English summary of GTS' written view to the NC TAR draft code amendment decision as published on 5 March 2018 by ACM. GTS submitted its formal view in Dutch to the ACM on 25 May 2018. This English summary is for information purpose only.

1. Introduction

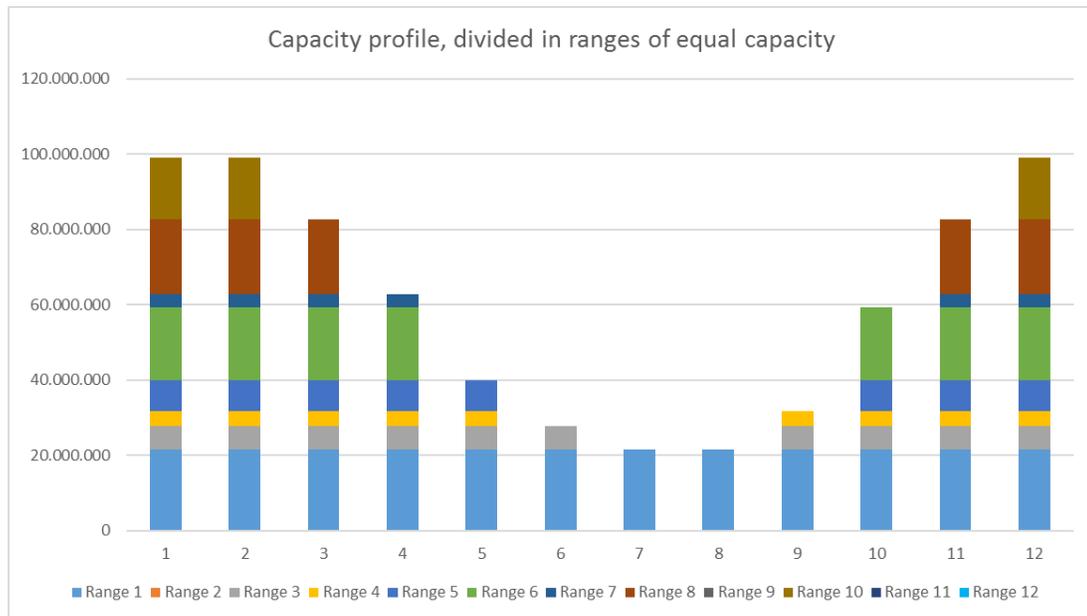
range if the sum of the shorter-term capacity products is more expensive than the longer-term capacity product (even though they were not planning to use that capacity in all months in advance). See below for a typical RNB profile the "grey" range (range 3).

If this grey range 3 had to be contracted according to the capacity profile with quarterly products (Q1, Q2, Q4) and monthly products (September), this would cost approximately 1.14 * the annual tariff. The shipper who has the choice himself then proceeds to purchase the annual capacity product for that range. The same mechanism can be used for the other ranges. De facto this 'product optimization' leads to an optimal booking consisting of standard capacity products with standard prices. In short: the shipper is able to realize the tariff optimization proposed by ACM through product optimization. GTS sees one possible "disadvantage" being the fact that for financial reasons capacity is booked that may not be used (possible hording). However, if we look at the current profile and period bookings, we can distinguish three groups:
